REGIONAL REVIEW NOTICE

ARC REVIEW CODE: R1703221

Name of Proposal: Saben Fairburn South Distribution Center (DRI 2665)

2665 SABEN FAIRBURN SOUTH DISTRIBUTION CENTER DRI
City of Fairburn
Natural Resources Division Review Comments

DRI PLAN #2665

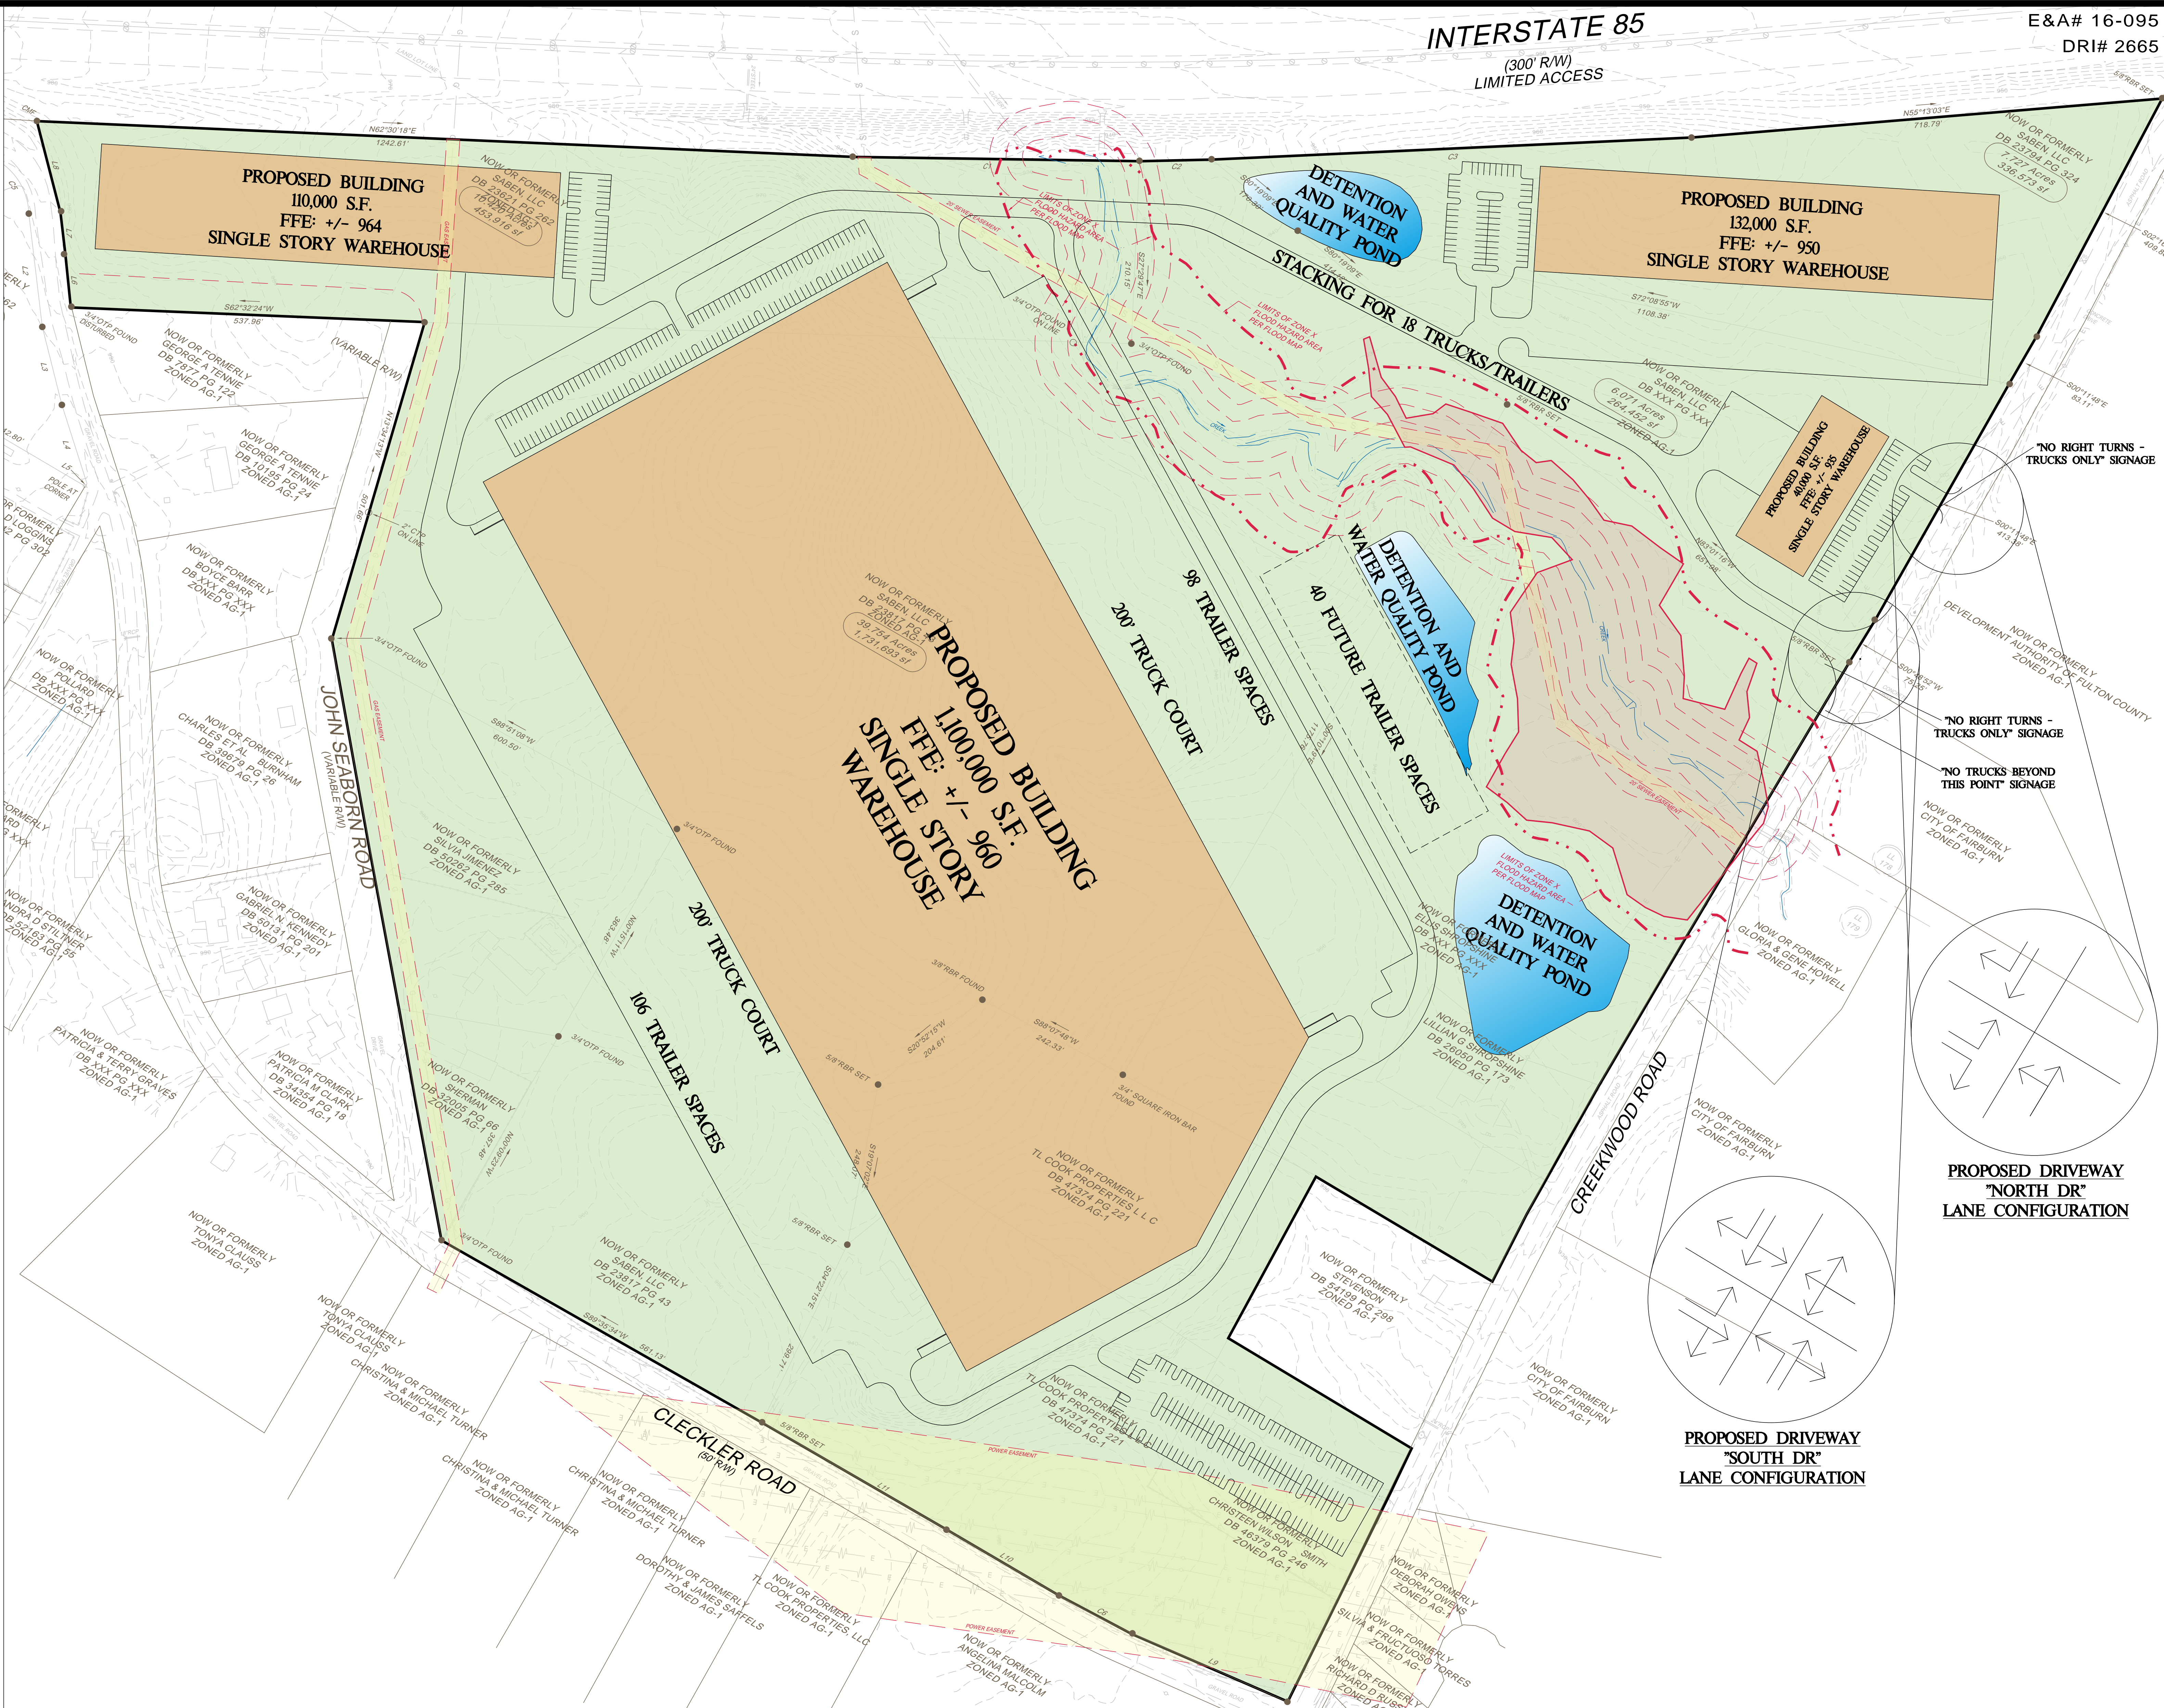
The proposed project is located within the Line Creek Water Supply watershed, a small (less than 100 square mile) watershed which is a water supply source for both Coweta and Fayette counties, both of which are in the Metropolitan North Georgia Water Planning District. The proposed project property is more than 7 miles upstream of both the County and City intakes. The USGS coverage for the project area show one blue-line stream crossing the project property. The stream is also shown on the submitted site plan.

As stated above, the USGS coverage for the project area shows a blue line stream on the property running north to southeast from the mid-point of the property line with the I-85 ROW to just northeast of the midpoint of the property line with the Creekwood Road ROW. The submitted site plan shows the stream with no other streams or tributaries indicated. The 25-foot State Sediment and Erosion Control Buffer as well as a 50-foot undisturbed buffer and 75-foot impervious surface buffer are shown around all streams and wetland areas. The 50-foot and 75-foot buffers are consistent with both the Part 5 Water Supply Watershed Minimum Criteria and the City's stream buffer ordinance. However, an access drive parallel to the northern truck court of the 1,100,000 SF building, and a stream crossing accessing that building and the 110,000 SF building, are shown as intruding on the buffers. Any intrusion into the State, City or water supply watershed buffers may require a variances. Any other streams on the property may be subject to the City and water supply watershed buffers as well as the State Sediment and Erosion Control buffer. Any other waters of the state that may be on the property will also be subject to the State Sediment and Erosion Control Buffer.

The site plan shows proposed detention and water quality ponds adjacent to the proposed developed areas of the property. The final design for stormwater controls on the property should adequately address the impacts of the proposed development on stormwater runoff and downstream water quality. Also, during construction, the project should conform to the relevant state and federal erosion and sedimentation control requirements. After construction, as with all development, water quality will be impacted due to polluted stormwater runoff. The amount of pollutants that will be produced after construction of the proposed development are dependent on the type and intensity of the use and the impervious coverage, which will affect the design of stormwater controls for the project.

The site plan and traffic analysis indicates two (2) access points proposed on Creekwood Road. Creekwood Road is a local road and is not designated as a Regional Thoroughfare.

Bus Transit service currently operates in the west side of I-85 south. No bus transit service is provided closer to the site. Pedestrian and bicycle facilities currently do not exist along Creekwood Road. The site plan and traffic study does not propose sidewalk along roadways adjacent to the development.

The development proposes industrial uses adjacent to existing residential uses. The site plan and traffic analysis indicate that no opportunities for future internal roadways connectivity with adjacent parcels is being proposed.

The site plan and traffic analysis does not indicate bicycle and pedestrian facilities being provided internal to the development or along adjacent roadways. Any pedestrian traffic on site would appear to intermingle with vehicular traffic with no indication of separate facilities for the different modes.

The site plan shows two full movement access points on Creekwood Road. One access point (#1) located northernmost portion of the site, enters a vehicular parking lot providing access to one building. Access point one provides for separation among truck and vehicle traffic. The second access point (#2) provides vehicles and trucks with access throughout the site. The site plan and traffic analysis does not indicate bicycle and pedestrian facilities being provided internal to the development or along adjacent roadways. Any pedestrian traffic on site would appear to intermingle with vehicular

traffic with no indication of separate facilities for the different modes. Movement throughout the site is provided by one driveway that connects freight trucks and vehicles to designated parking areas.

Due to concerns regarding integrity of an existing bridge along Creekwood Road south of the site, trucks are prohibited from making right turn movements out of the development. Signage directing freight traffic from the development are provided internal to the site and along external roadways.
